**Planning Commission Hearing Date: May 5, 2026**  
**Board of Commissioners Hearing Date: May 28, 2026**

**STAFF ANALYSIS**

<b>CASE NO.:</b>	SLUP-26-1248044	<b>File ID #:</b> 2026-0490
<b>Address:</b>	4733, 4773 & 4775 Memorial Drive, Decatur, GA 30032	<b>Commission District: 4 Super District: 6</b>
<b>Parcel ID(s):</b>	18 012 13 033, 18 012 13 015, 18 012 13 001	
<b>Request:</b>	Application of QuikTrip Corporation for a Special Land Use Permit (SLUP) to allow fuel pumps in the Town Center character area in the C-1 (Local Commercial) zoning district	
<b>Property Owner(s):</b>	QuikTrip Corporation C/O Eric Bikas	
<b>Applicant/Agent:</b>	QuikTrip Corporation C/O Eric Bikas	
<b>Acreage:</b>	5.23	
<b>Existing Land Use:</b>	Town Center	
<b>Surrounding Properties:</b>	<b>North:</b> C-1 (Local Commercial) <b>South:</b> C-1, R-100 (Residential Medium Lot-100) <b>East:</b> C-1, R-100 <b>West:</b> C-1	
<b>Comprehensive Plan:</b>	<b>Consistent</b>	<b>Inconsistent X</b>

**STAFF RECOMMENDATION: APPROVAL WITH CONDITIONS.**

SHEET TITLE:  
SITE PLAN

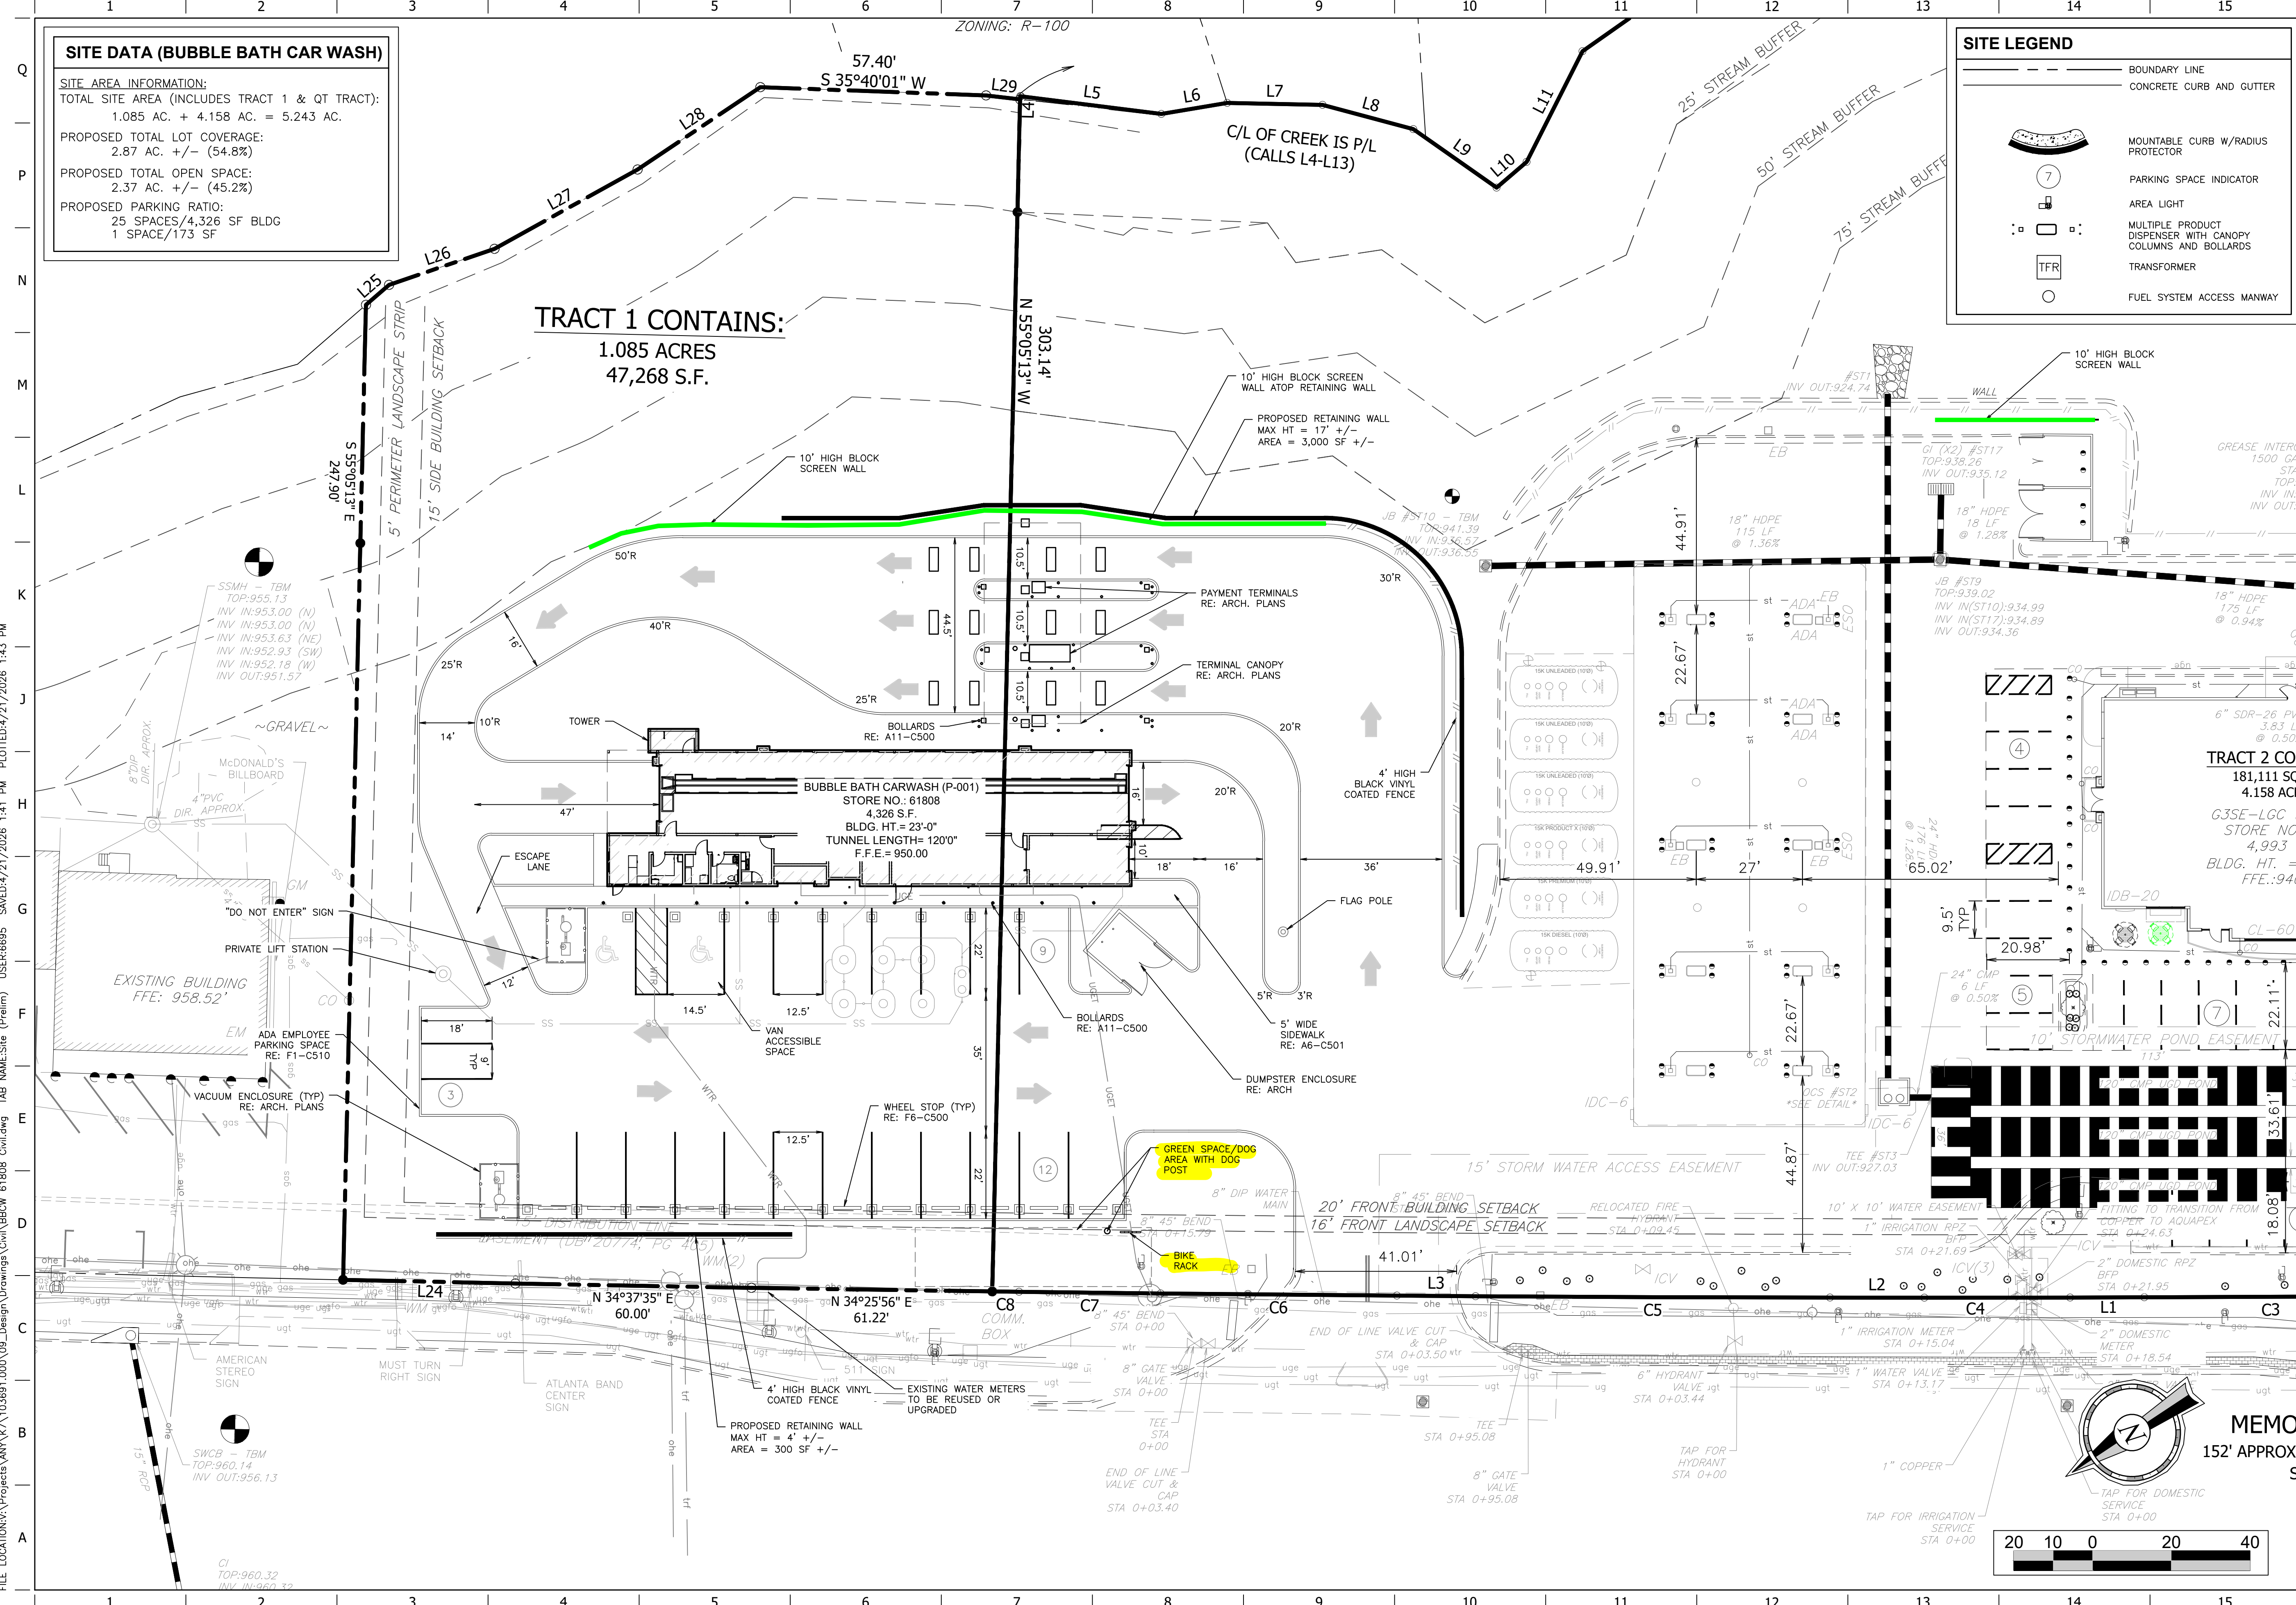
1. The site plan shall enhance pedestrian connectivity between the public sidewalk along Memorial Drive and building entrances, including clearly defined walkways and connections to the outdoor seating and greenspace areas prior to any future Permit(s) and/or business renewal application – whichever comes first.

2. The development shall incorporate a placemaking feature that reflects the identity of the Memorial Drive Corridor, such as public art, decorative signage, or architectural enhancements. The design and placement shall be subject to written approval by the Planning Deputy Director prior to any future Permit(s) and/or business renewal application – whichever comes first.

3. The site plan shall include an expanded, covered outdoor seating area integrated with the convenience store entrance prior to any future Permit(s) and/or business renewal application – whichever comes first.

4. A publicly visible greenspace shall be incorporated into the site design prior to any future Permit(s) and/or business renewal application – whichever comes first.

Full stormwater system is needed with extra measure because this will be consider a hotspot

There is a creek that flows in the back of the property

Operation of fuel pumps or related activities automatically qualify this site as a "stormwater hotspot". Therefore, approved best management practices (BMPs): structural and non-structural are required to ensure compliance with the County's MS4 program and the NPDES permit requirements. A detention facility is required per Sec. 14-40(b)(4) of the code of Ordinance.
